ANN ARBOR PLANNING DEPARTMENT STAFF REPORT

For Planning Commission Meeting of May 1, 2012

**SUBJECT: Chalmers Place Employee Parking Rezoning and Site Plan
(2090 Chalmers Drive)
SP12-010 & Z12-003**

ORIGINAL ISSUE DATE: FEB. 23, 2012
PEA JOB NO. 2011-119
SCALE: 1"=20'
DRAWING NUMBER: **L-1.0**

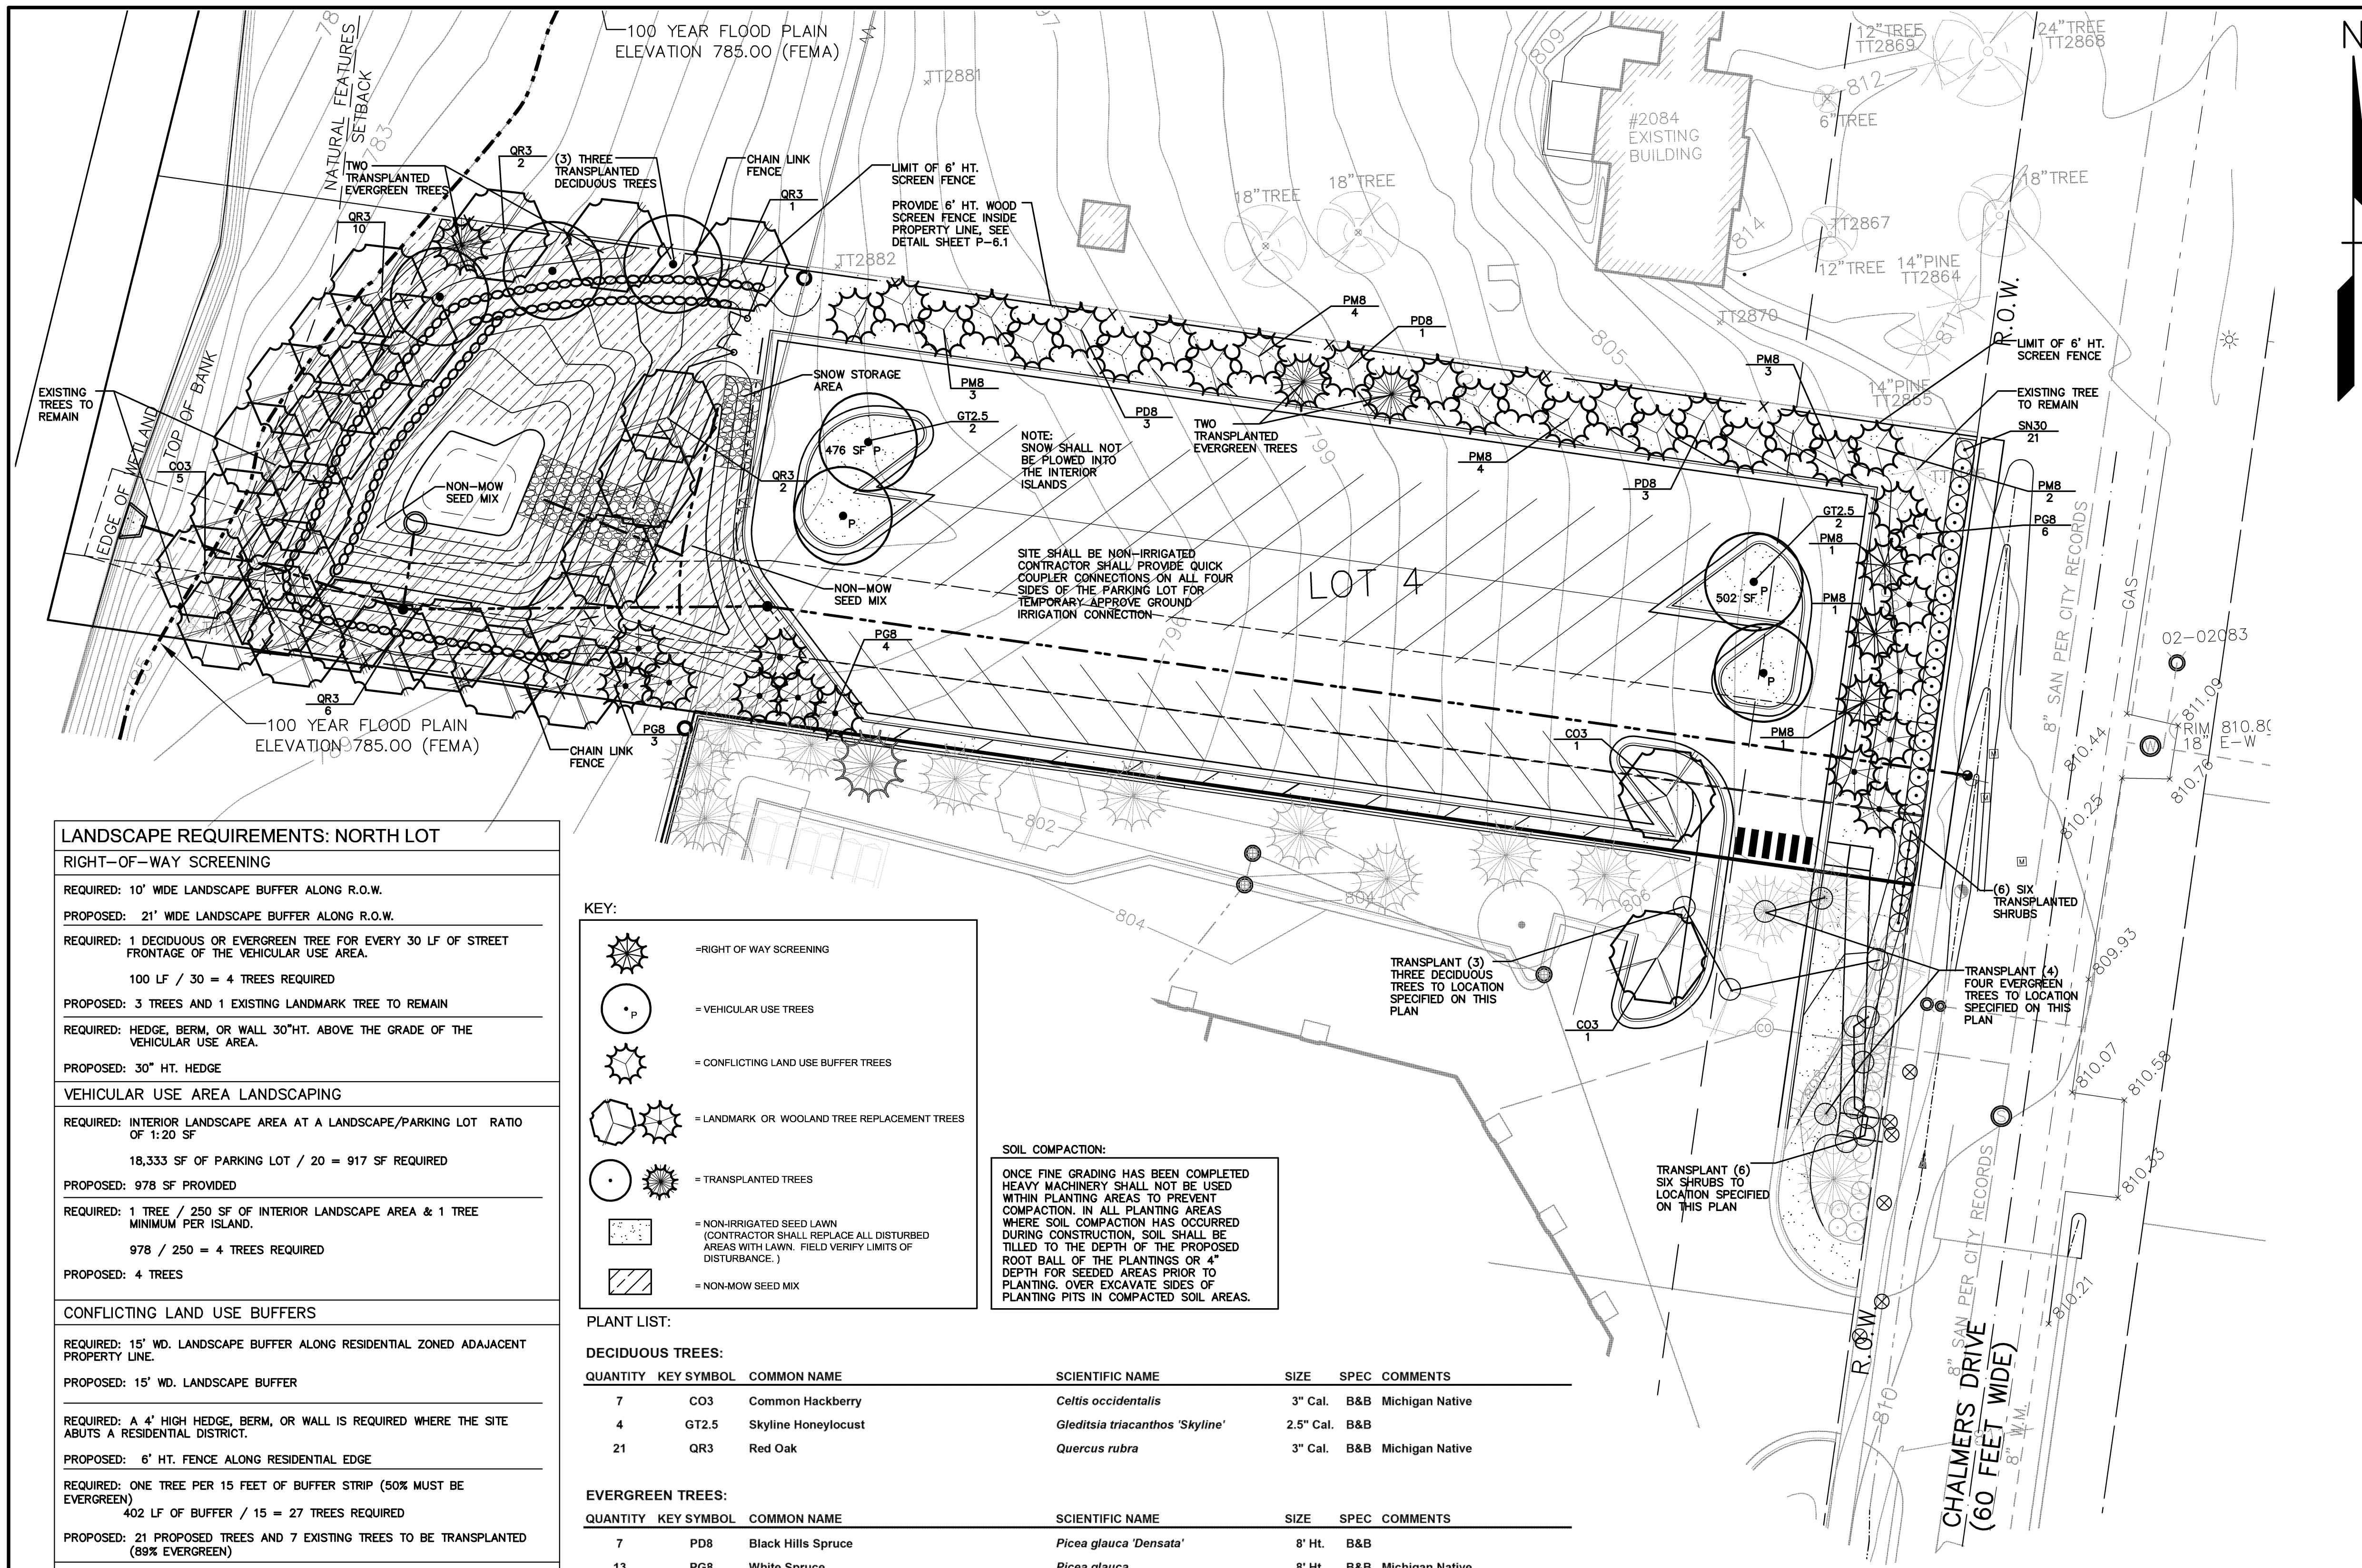
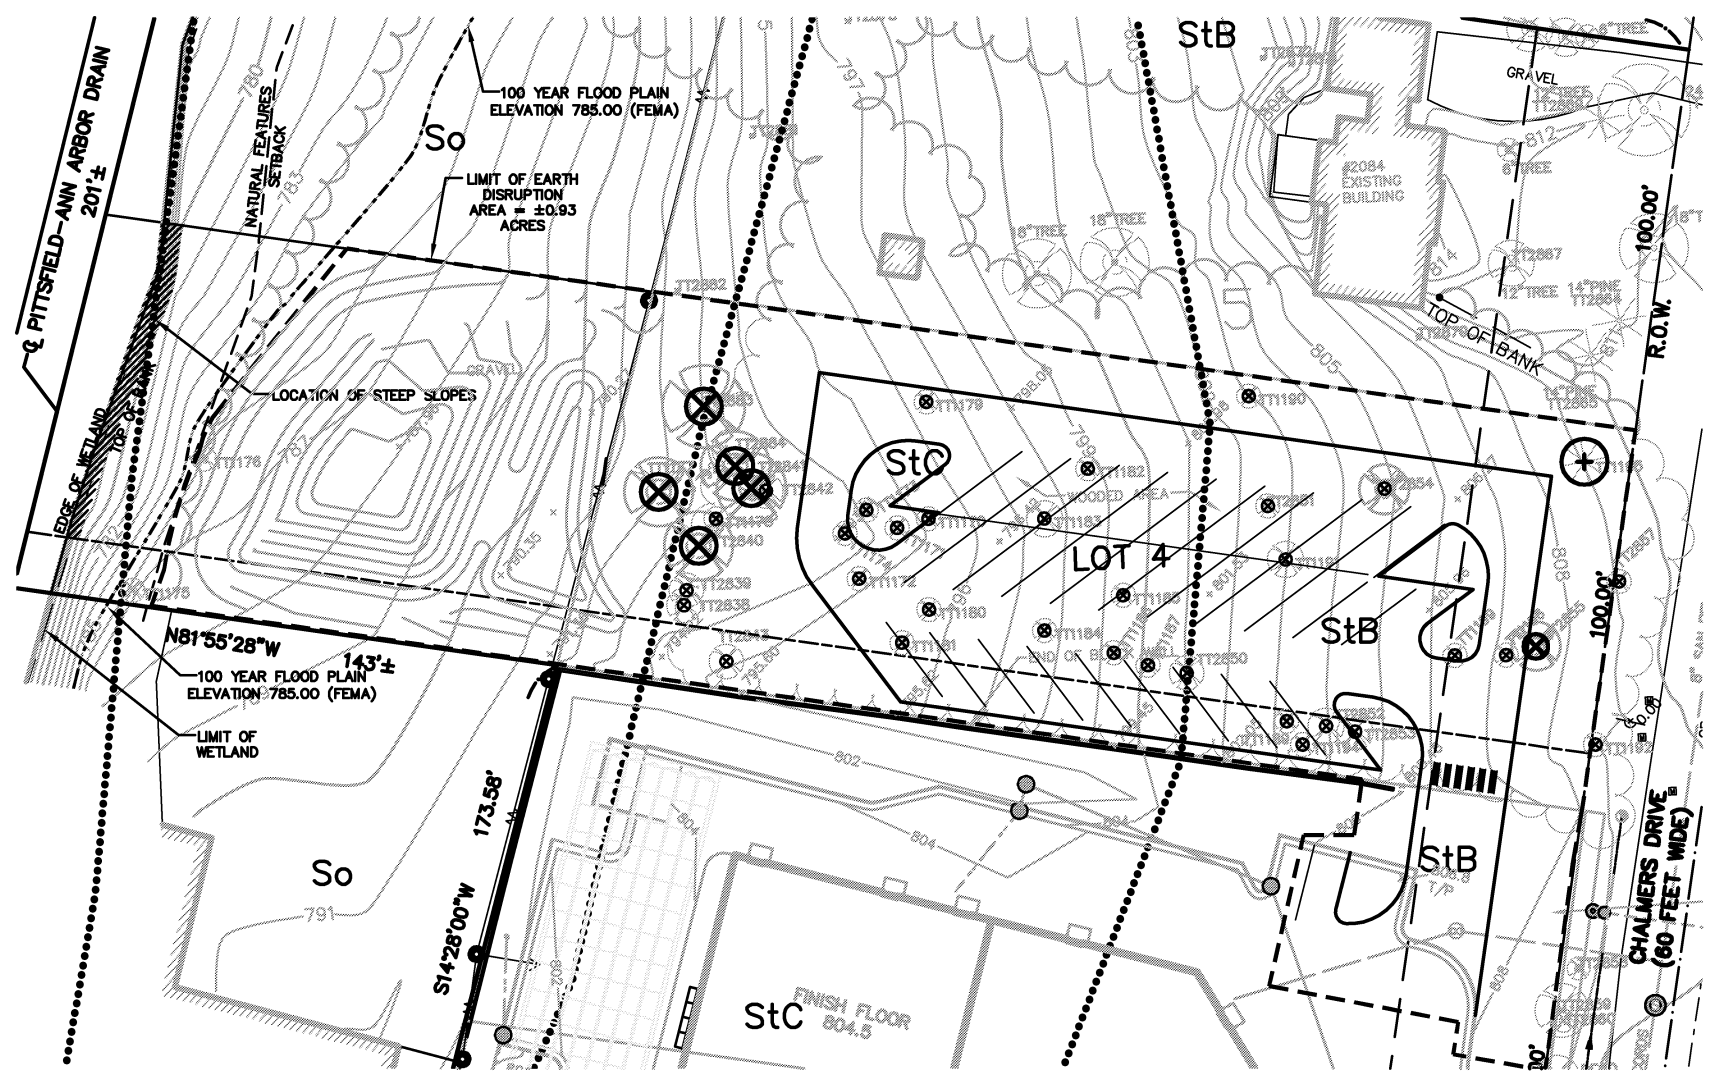
Staff Response: The only natural features alternative analysis provided on Sheet L1.0 (Natural Features Plan) is the reduction in the number of parking spaces. Staff has included alternatives to consider in Natural Resource Review #1 and #2, however, none of the staff alternatives have been mentioned in the petitioner’s response letter or on the site plan. Please review the design and look at alternatives to preserve the landmark trees on site and if they are unacceptable, explain why. Alternatives to consider include, but are not limited to:

- Reducing the size of the right-of-way buffer--21 feet is provided but only 10 feet is required.
- Not providing the AATA parking and reducing the number of parking spaces in the parking lot.
- Utilizing the western 1/3 of the site that is already compacted for a portion of the parking lot with underground detention. Create a large island around the landmark trees with a drive to the south of the landmark trees that can connect to a much smaller parking lot on the east.
- Request a variance to add additional parking spaces on the west side of Chalmer’s Place.

Petitioner Response: Using the already disturbed western 1/3 of the site for parking and using underground is a good idea from the perspective of tree preservation, however, it adds over \$115,000 of cost to the project by the addition of an \$80,000- \$90,000 underground detention system, additional impervious, and additional storm sewer, and pre-treatment structures etc. The \$115,000 cost is not a feasible or prudent alternative to preserving a handful of trees in a large parking lot island where their health may be compromised by the dramatic change in site drainage. That is why replacement trees were preferred. Also, we attempted to reduce the buffer as suggested to save a few trees, but it was questionable if the existing trees would live due to grading requirements in that area so we stuck with the layout that functioned better in terms of drive alignment and vehicular circulation from the existing development. In addition, the wider buffer along Chalmers is highly desired to create suitable planting space for a double row of trees to hide the development from the road and neighboring homes. This is really important to the homeowner across the street. In terms of eliminating AATA and adding parking to the existing Chalmers Place parking lot, those are programmatic decisions that were made at the onset of the project. The owner is somewhat open minded about those options, but felt that this was the only approvable path.
